GOVERNMENT OF MADRAS.

PUBLIC WORKS DEPARTMENT.

G.O., 10th March 1883, No. 788 W

*Regarding the preparation of a new design
of — to harmonize with Cutcherry build-
ings.*

STANDARD PLAN OF A SUBREGISTRARS OFFICE.
TERRACED BUILDING.

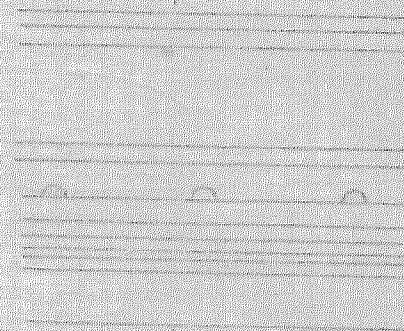
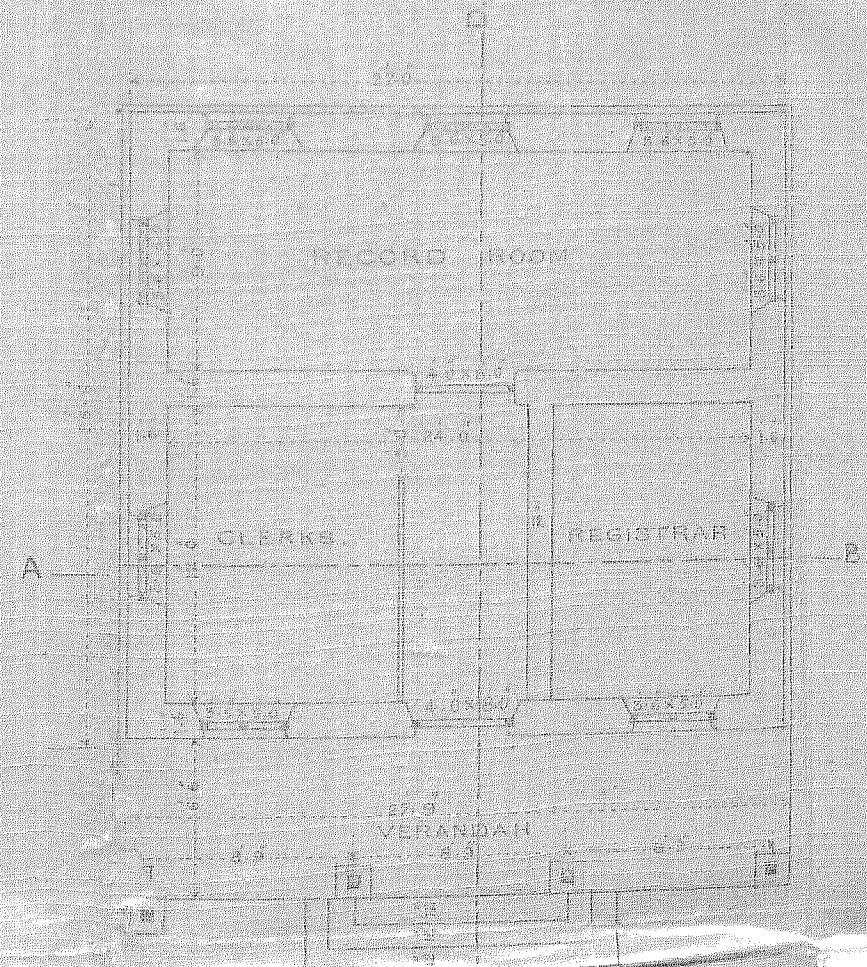
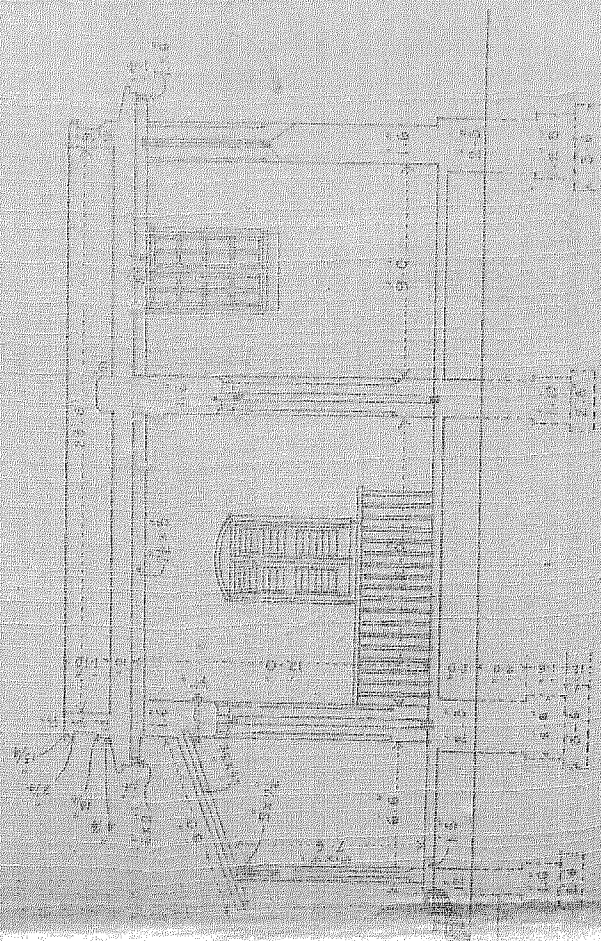
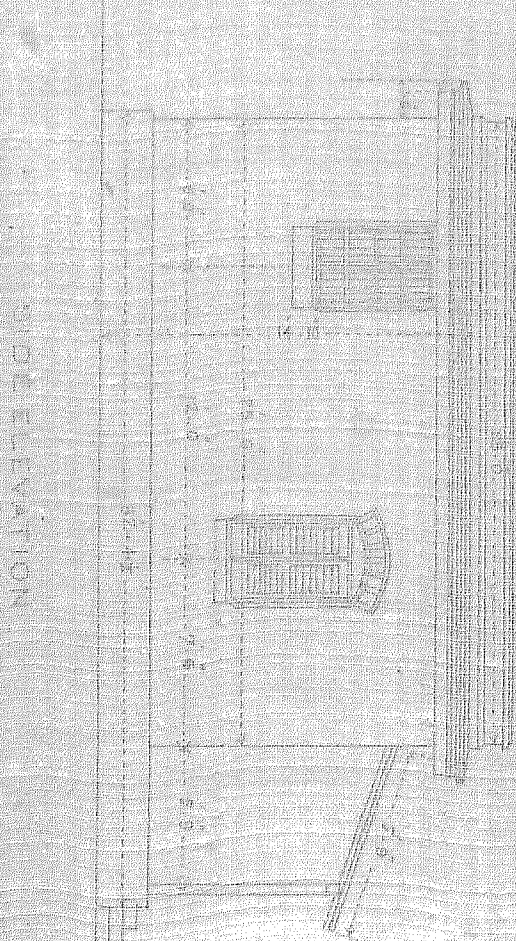
He wishes for all new Sub-Registrars' offices the design copy enclosed to be used.

2. I object to a terraced roof in the same compound with Mr. Chisholm's Standard Cutcheries, which are all tiled and in a different style. I have no objection to terraced roof elsewhere.

3. The danger of fire is, I believe, his reason. I believe that tiled buildings designed so as to harmonize, or at least not to be in violent contrast, with the style of the new Cutcheries may be made to all intents and purposes very nearly as safe as terraced buildings, and quite safe enough.

4. The risk would be exceedingly small, the offices being all closed at night, and might be further diminished by orders that all registration business be conducted by daylight. To provide a small additional security for a very small and remote risk it seems to me a pity to sacrifice what good effect there is in Mr. Chisholm's new Cutcherry designs.

The Consulting Architect to Government is now engaged on the preparation * of a type design of Registration Offices which will afford the requisite security and at the same time harmonize with the design of Cutcherry buildings.

2. The new design should be submitted and circulated as soon as possible.
